**SERVICE BULLETIN**

**APPLICABILITY:** 2014-2016MY Forester Models  
 2012-2016 Impreza Models  
 2013-2016 Crosstrek Models  
 2015-2016MY WRX and WRX STI Models

**NUMBER:** 10-86-17R

**SUBJECT:** Blower Motor- Design Change to Address Operating Sound and Fan Speed Control Concerns

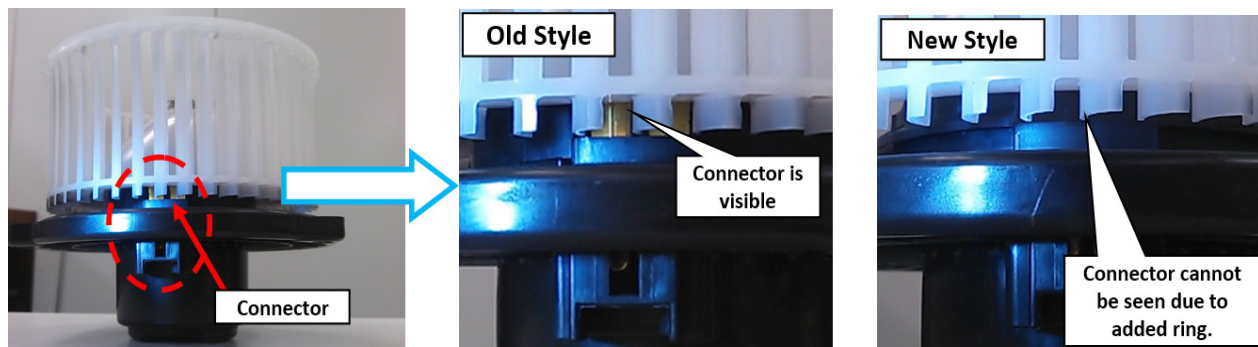
A design change was made to the blower motor assembly to address the following customer concerns:

- Blower fan is either inoperative or only operates on high speed.
- Excessive rotational-type sound heard when the fan is operating.

An additional ring of material has been added to the housing to protect the connector portion of the assembly from water intrusion and optimize durability.
